## **Exploring potential for a safe pedestrian crossing of the A371 to meet requirements of WM1 on Mendip Local Plan**

Current outline application 2025/0137/OUT submission does not fully consider sufficient options for provision of a safe pedestrian crossing of the A371.

Fig 1 – showing approx sight lines for “stopping sight distances” by speed

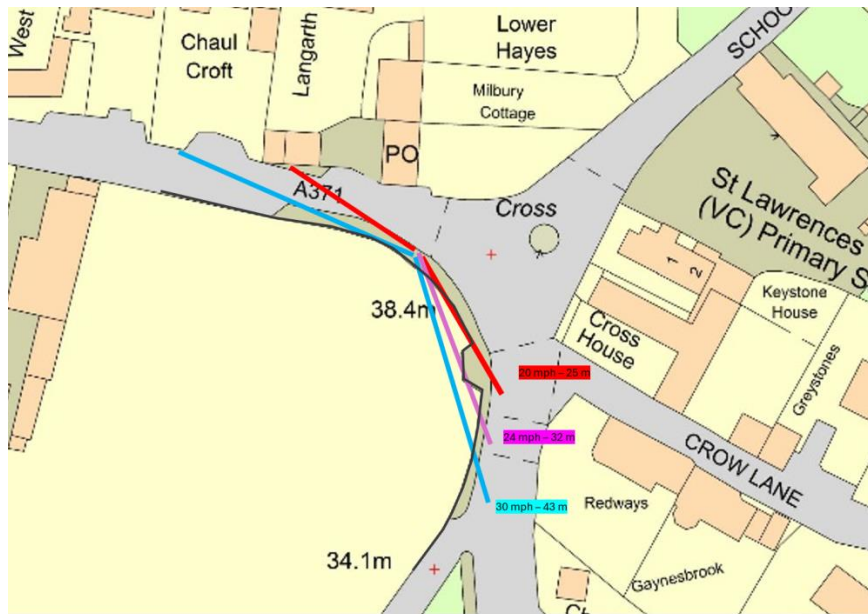
Does not offer sufficient sight line visibility for current speeds looking south towards Station Rd (Wells) nor provides sufficient pavement width for poles for lights / signage. We believe the sight line visibility looking east towards cheddar is already satisfactory.

See fig 1 for sight line estimation for 20 mpg; current 85 percentile speeds of 24 mph and for current speed limit of 30 mph (extracted from manual for streets)

*Fig 2 – Route of existing public footpath across Court House Farm garden*

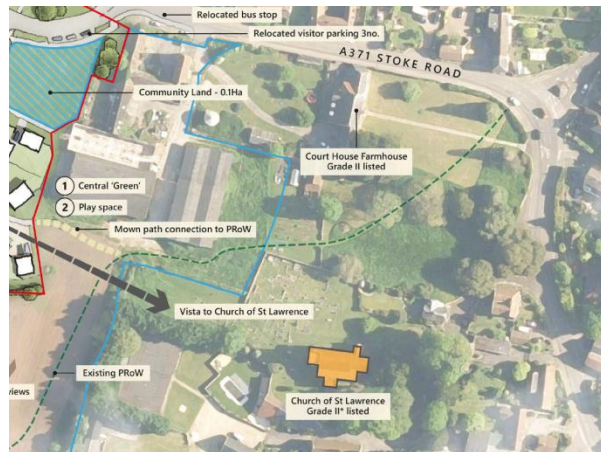
Land availability: The owners of Court House Farm have indicated they are open to being part of a solution if making available a slice of land would solve sight line and pavement width issues. They would require that the existing footpath across the front garden is diverted such that it does not cross part of their property. See Fig 2.

Footpath Diversion – There are a number of possible routes that a diverted footpath might take – either west along A371 and then south through proposed new RL access or south to land surrounding church and then west. The route that perhaps would make most sense from (line of desire) would be west along the A371. This alternative route was in use for many years prior to 2012. Footpath diversion assessment required (and pavement widths addressed).

Westbury Sub Mendip – Pedestrian crossing sight lines

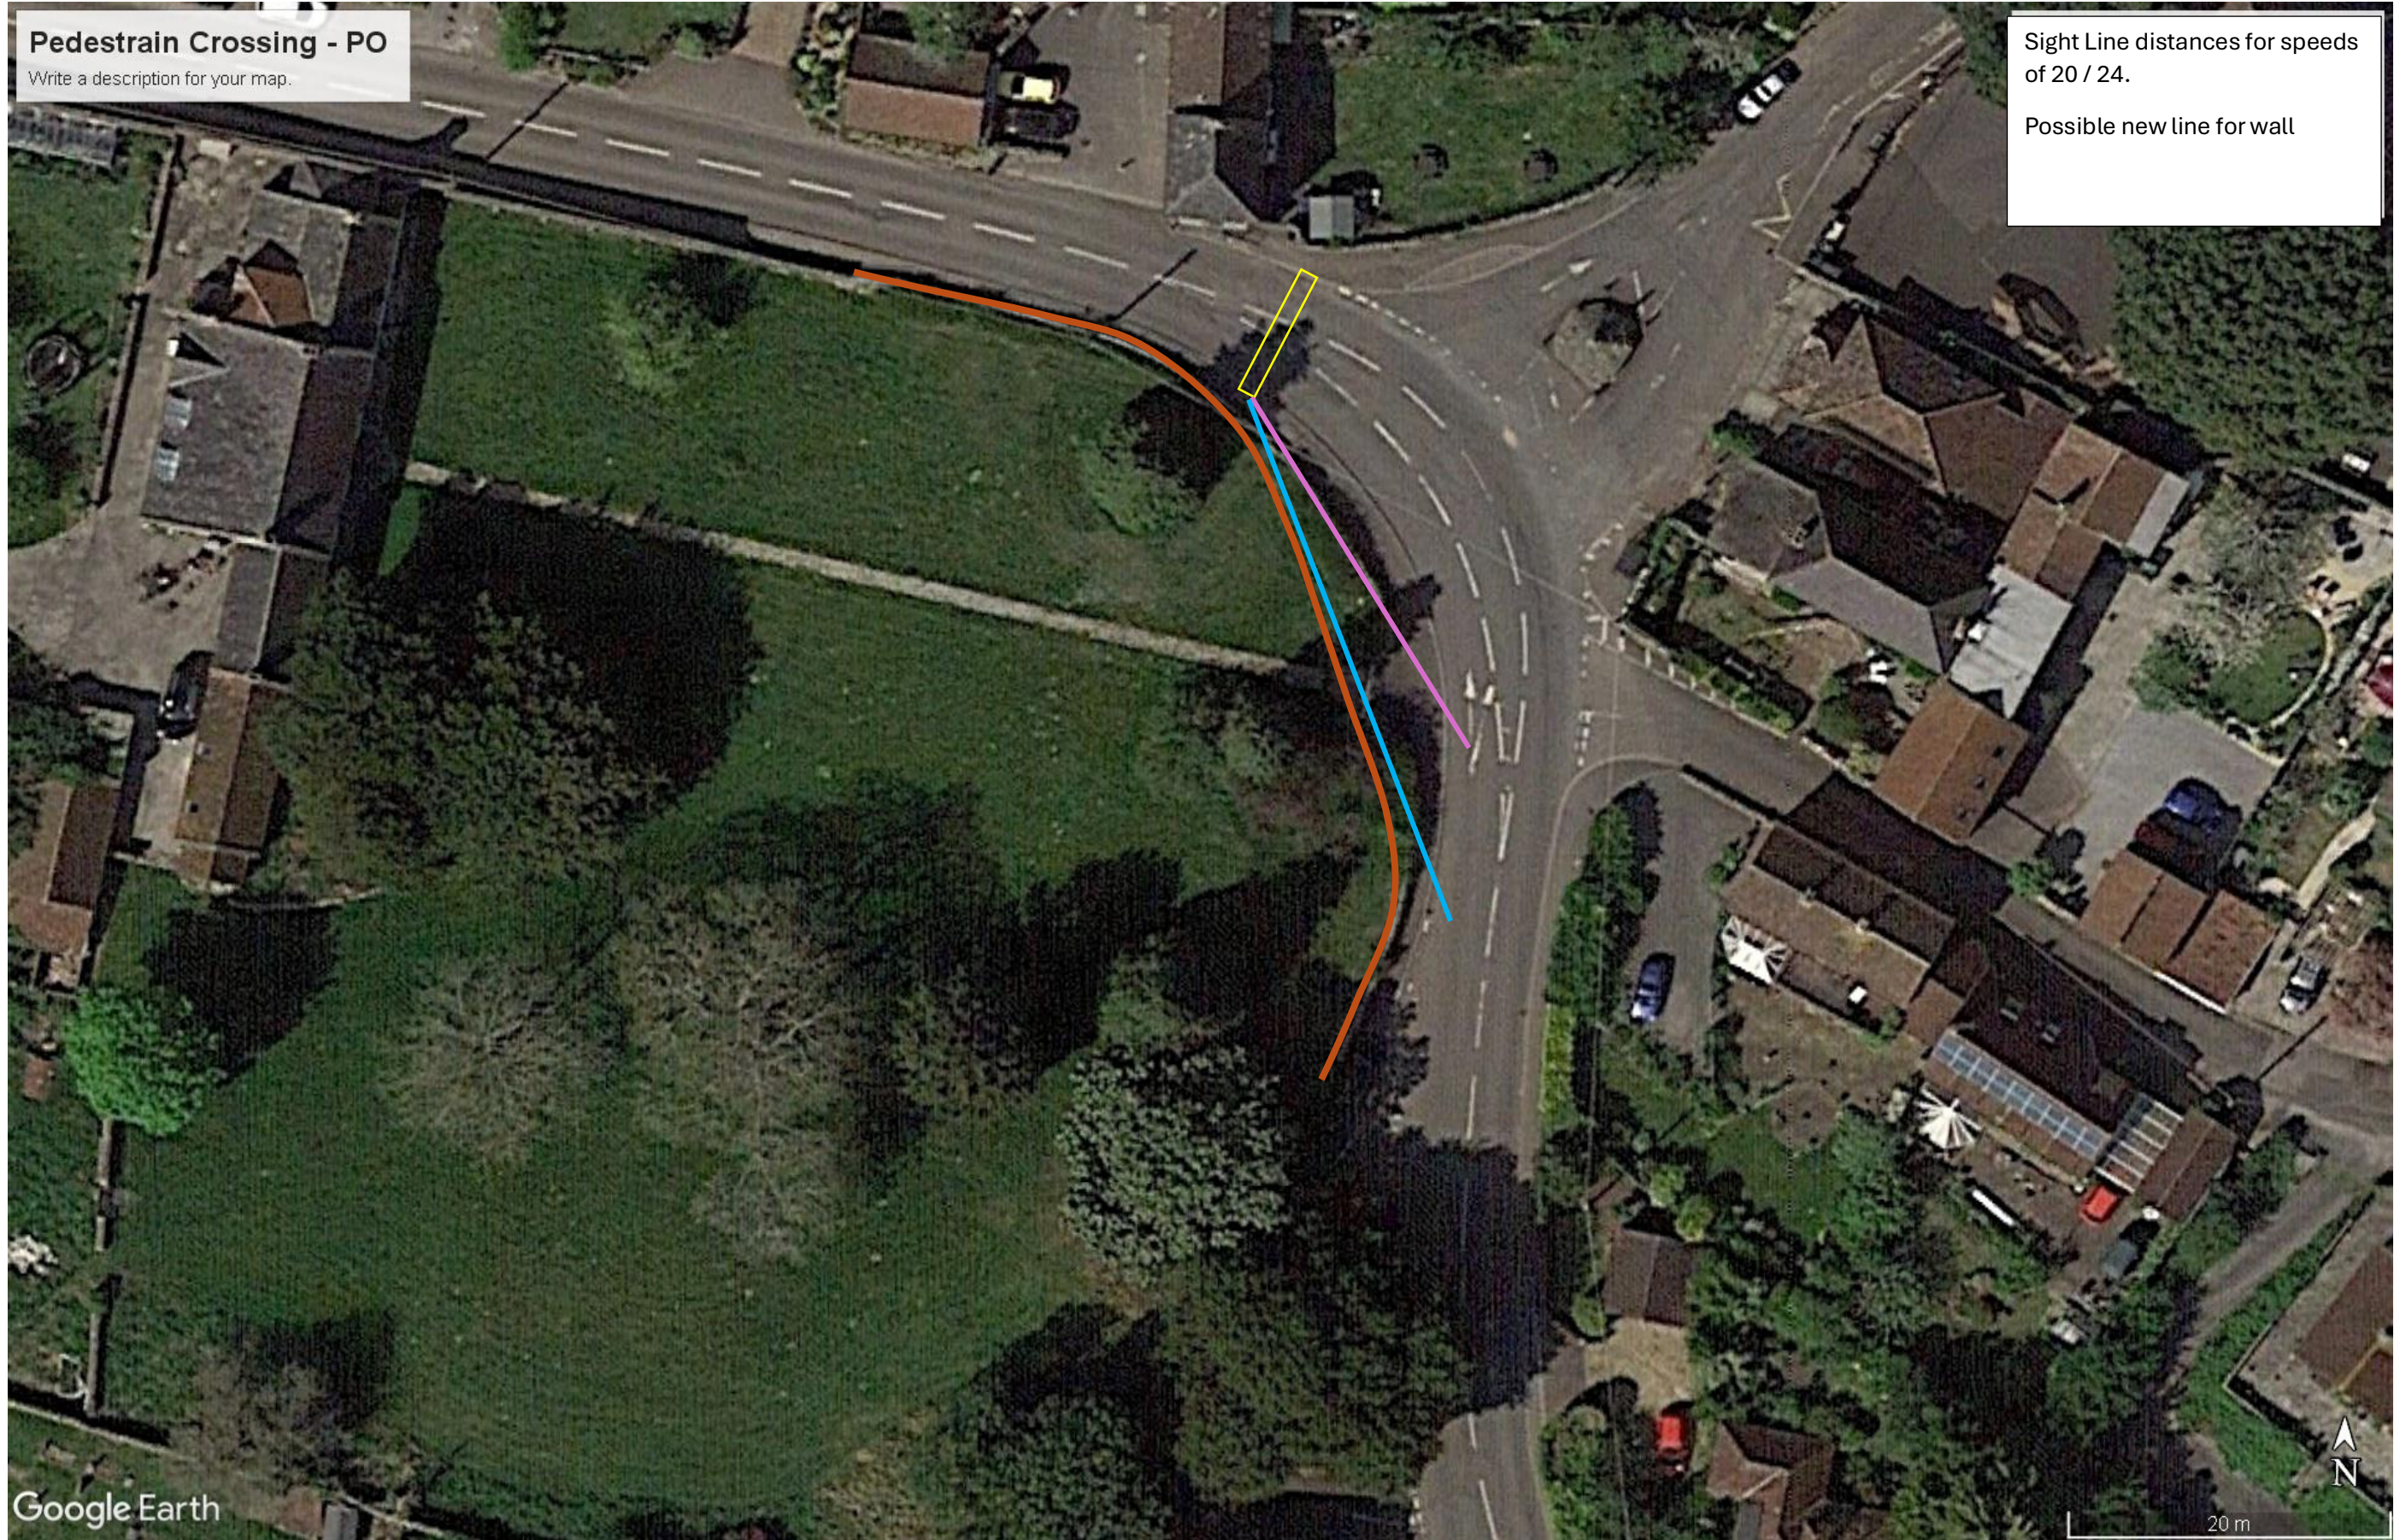
To illustrate the extent of any realignment / reduced height of the curtilage wall of Court House Farm that would be necessary (assuming a 24 mph speed sight line) please see attached doc titled "Sight Line Positions Draft 1"

Possible new line for wall
